Cumulative Impact - Averham Park and Knapthorpe Area

Post-hearing submissions, including written summaries of any oral cases made at the hearings held this can include parties detailing what they think is still an issue relating to the topics of the Devel

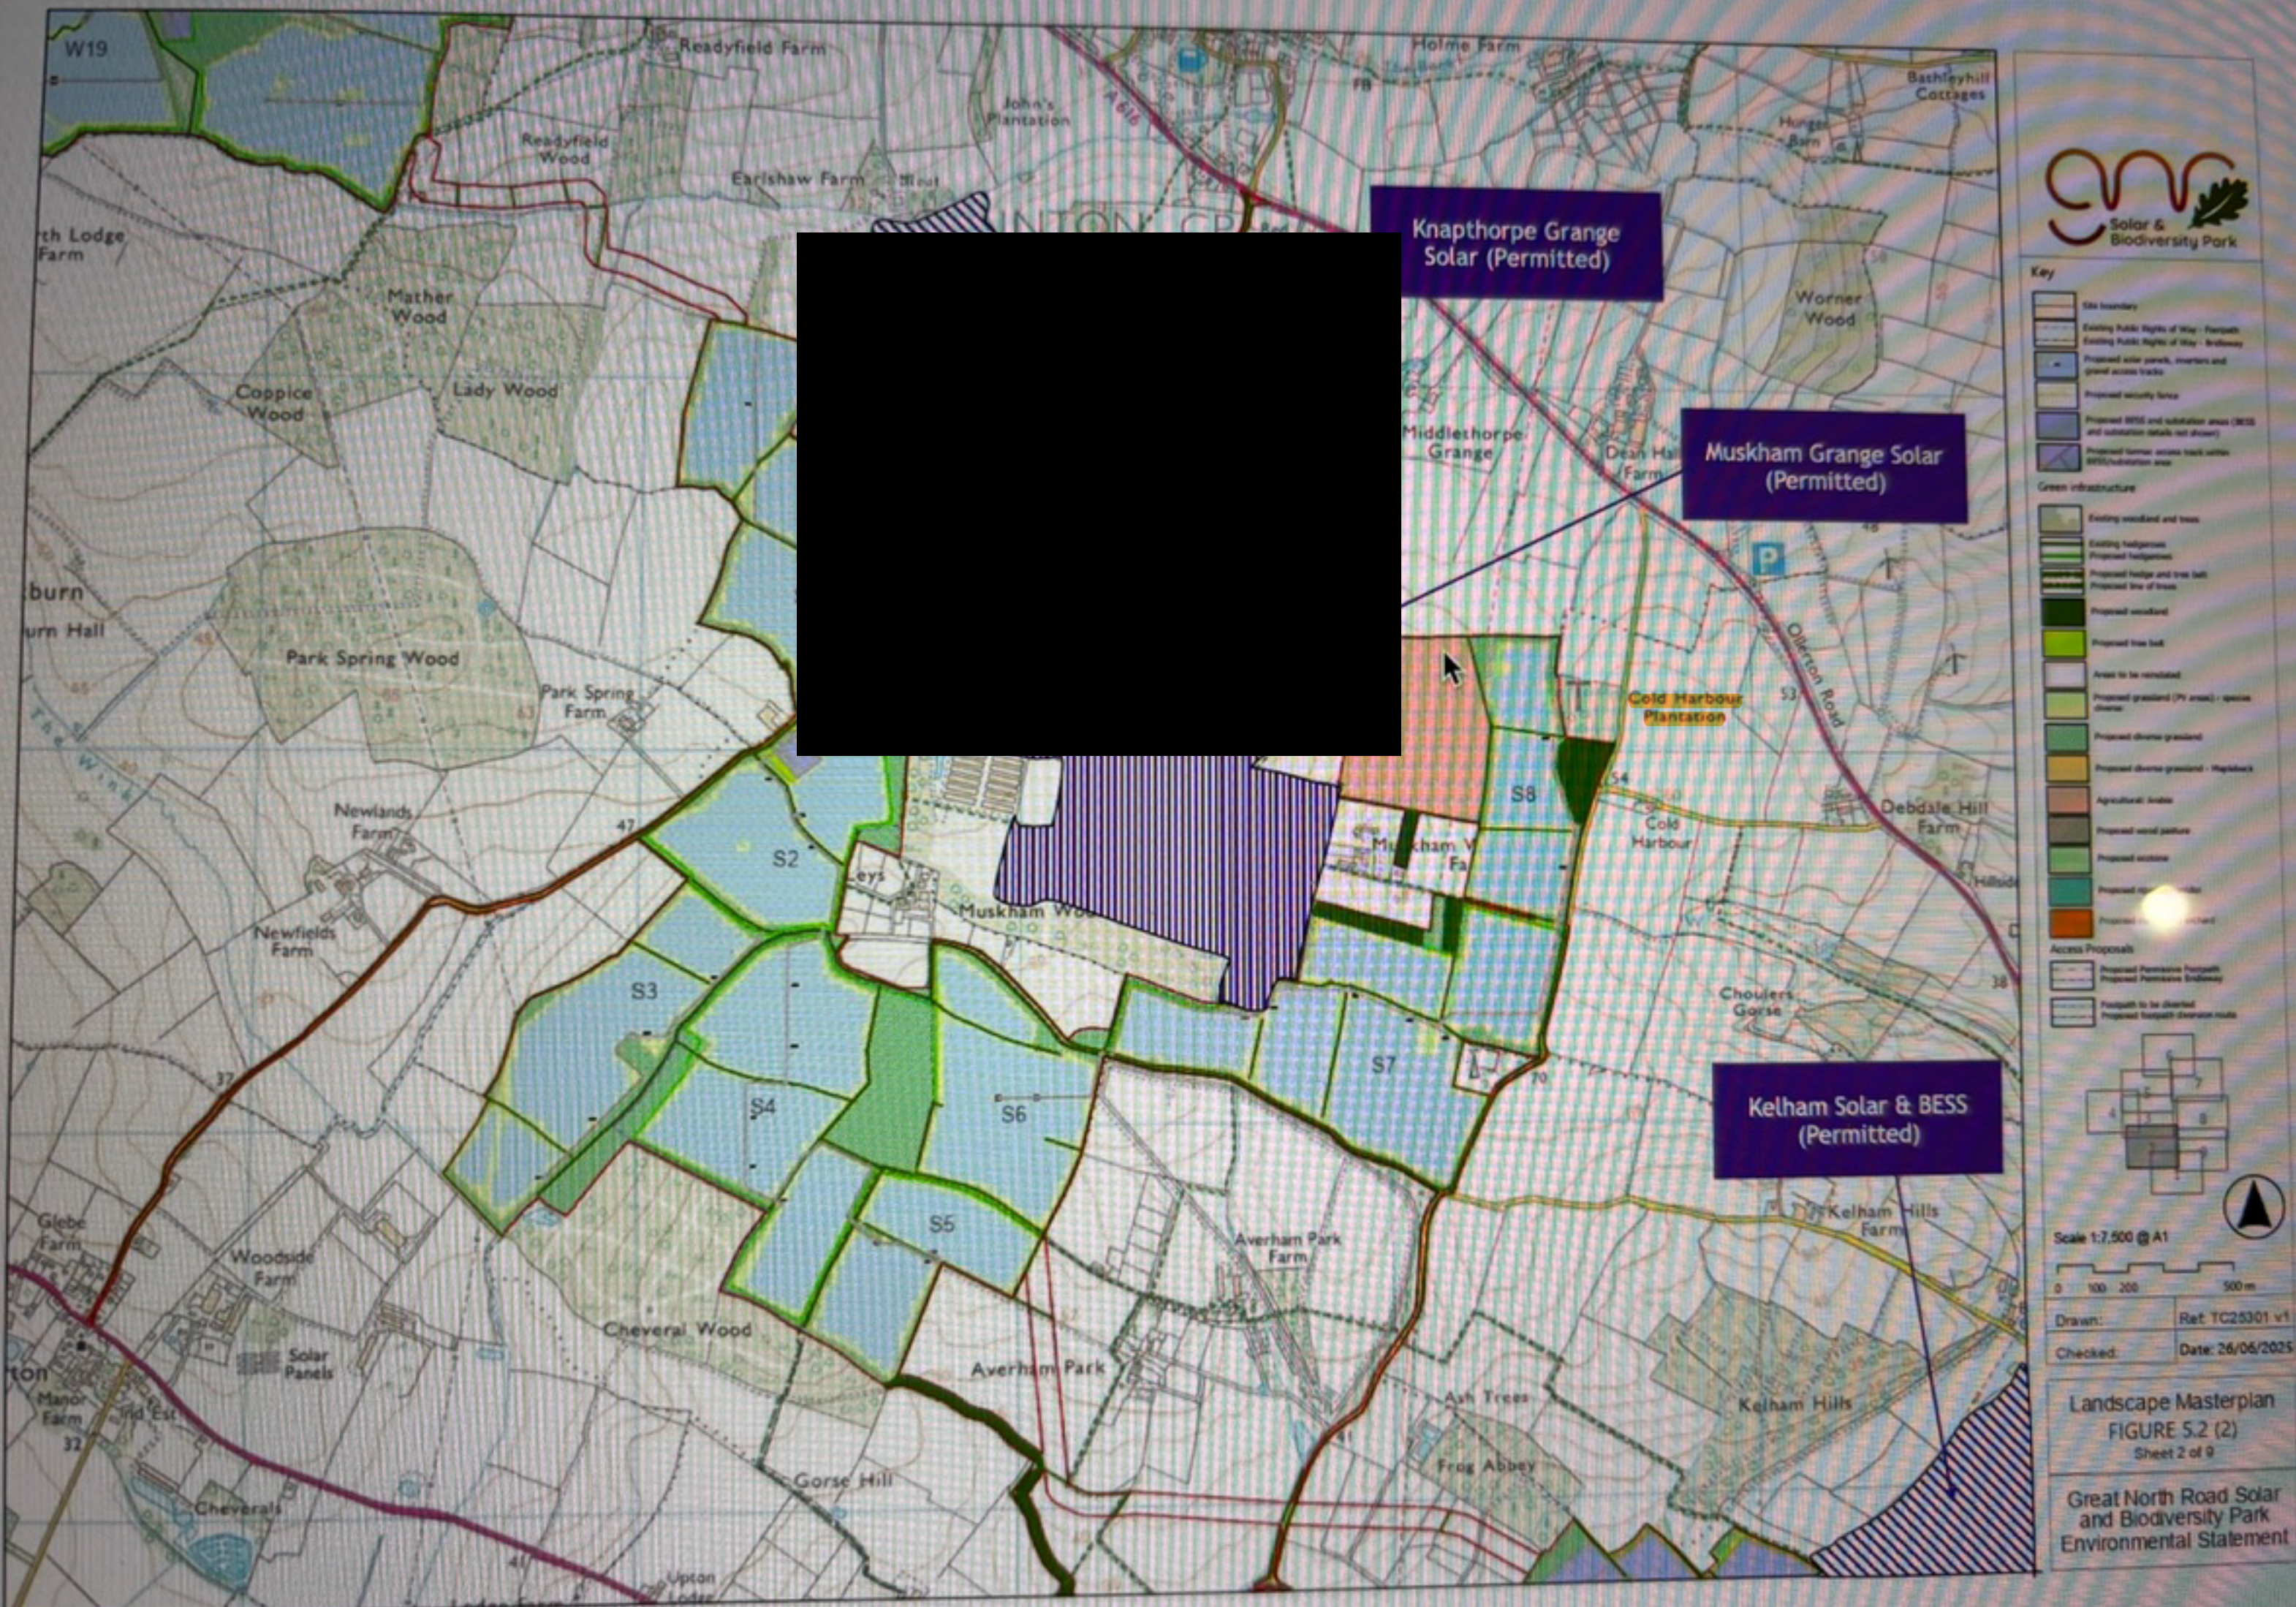
- Please see attached your cumulative assessment plot for the hamlet of Knapthorpe and the circle where our property is. We are being visually enclosed (the large GNR solar park and SSE solar farms are visually overbearing projects). The close proximity of these solar farms combined "cumulative impact" will create a sense of visual enclosure, and this will make us feel hemmed in by industrial infrastructure.

- We are asking for a condition in the DCO which mandates a larger buffer for panels near residential boundaries sited at Knapthorpe.
